RE: KILN NO. 2 INDIRECT FIRING MODIFICATION
TARMAC FLORIDA, INC.
PENNSUCO PLANT

Re: Kiln No. 2 Indirect Firing Modification
DEP File 0250020-007-AC (PSD-FL-142A)

Re: Permit Application for Kiln No. 2 Indirect Firing Modification (0250020-007-AC)

Figure 1: Direct Firing

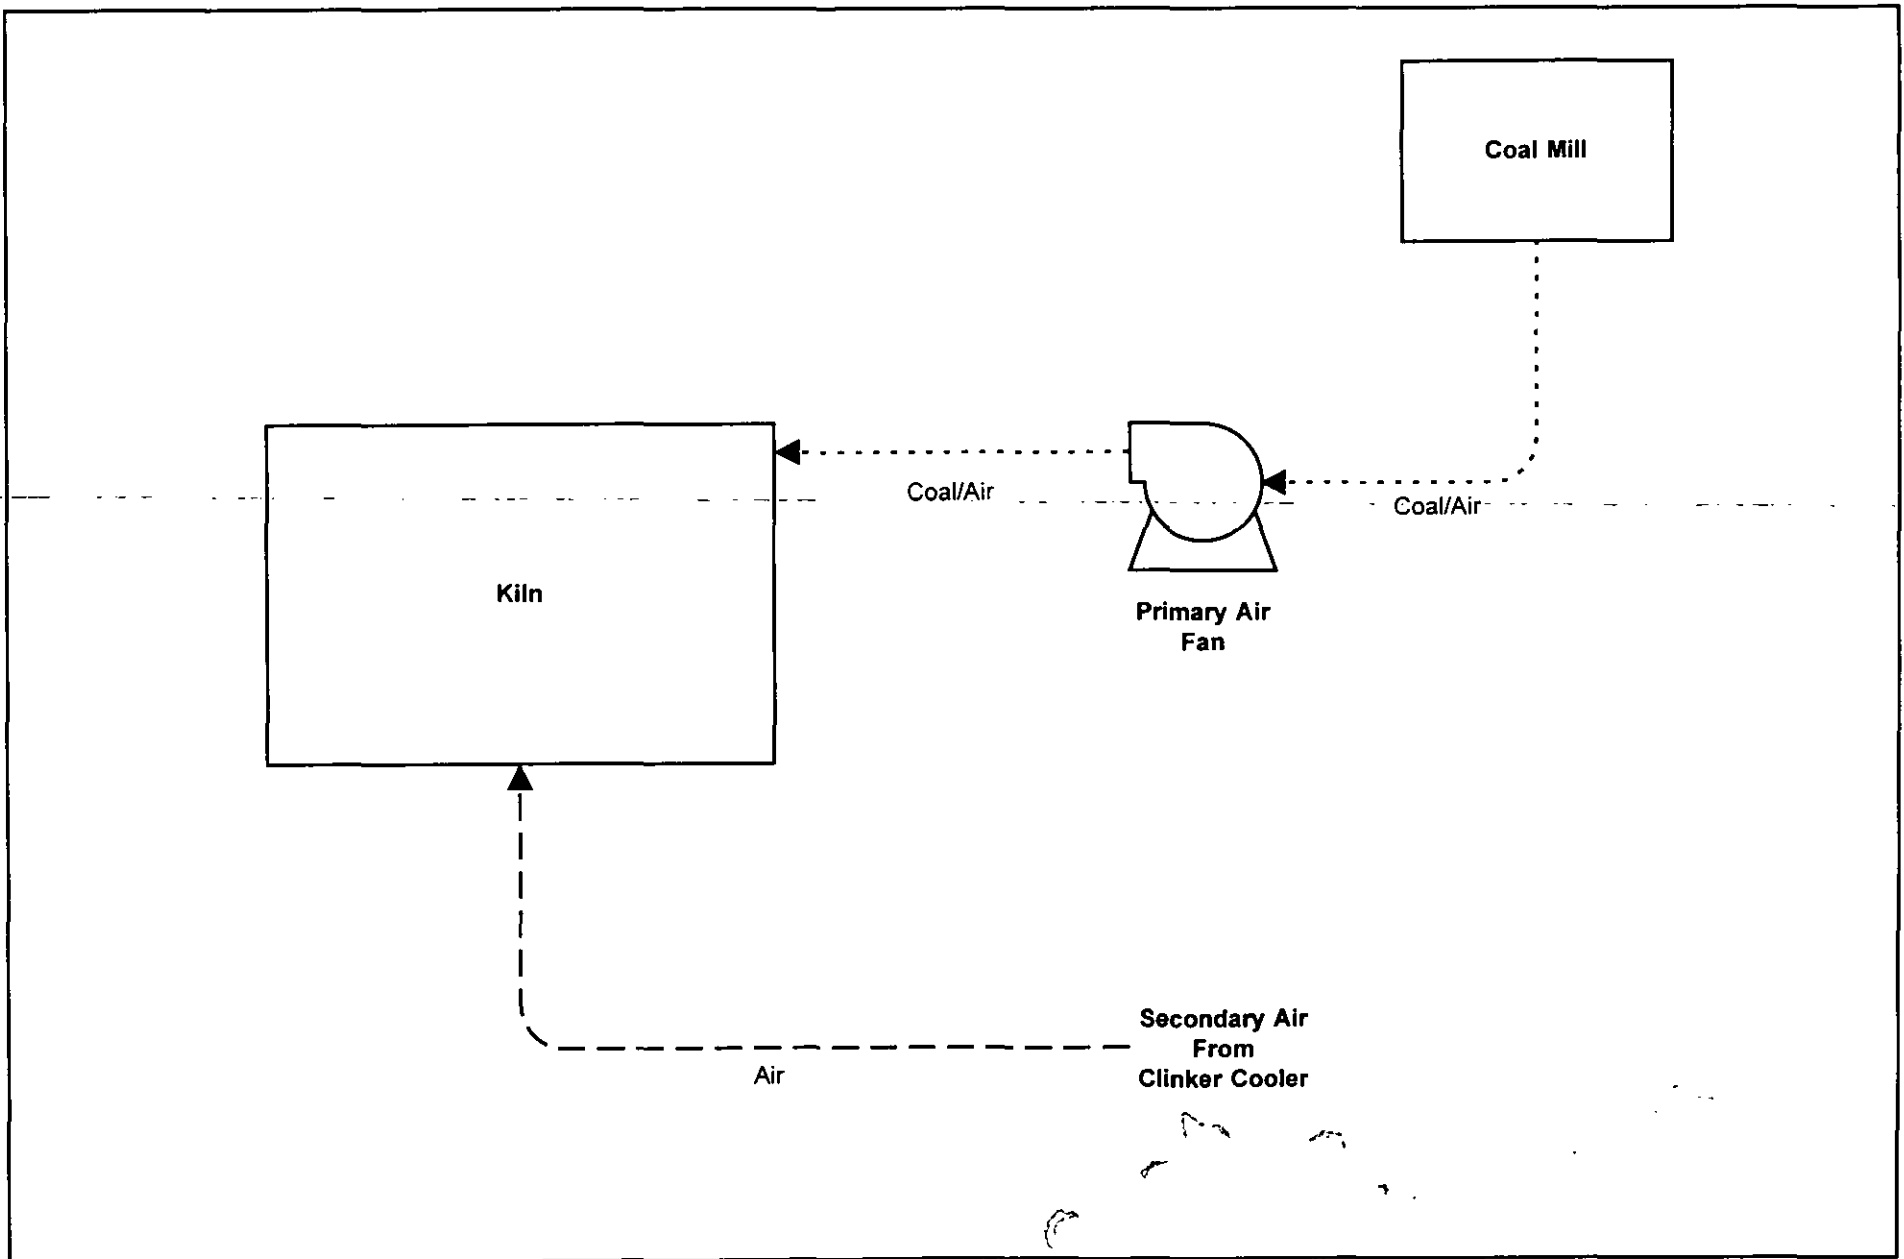
Since the expiration date of AC 13-169901 has passed, the new construction permit should encompass the entire Kiln No. 2 operation (i.e., more than just the new coal bin and baghouse) so that performance tests are required to demonstrate compliance after the retrofit is done. This means that the application must show complete pollutant information and should contain more drawings and a detailed description of the work to be performed. We note a minor error in the calculation of emissions on page III. Part 9b-1 field 8 (3.94 lb/hour should be 0.94 lb/hour). Amendments to the Title V permit will be required as well. As far as the fee is concerned, it is sufficient for the new baghouse emission increase (less than five tons per year) and since we are not requiring a new BACT review there is no need for a higher fee.

The physical change to indirect firing is portrayed in the attached flow diagrams. In the present direct firing method (Figure 1), coal from the coal mill is sent directly to Kiln No. 2 via the primary air fan. The primary air volume, which is a high volume flow, is determined by the amount of air needed to pneumatically convey the coal through the coal mill. The

primary air cannot be adjusted to result in lower emissions. Secondary air for the kiln is drawn from the clinker cooler.
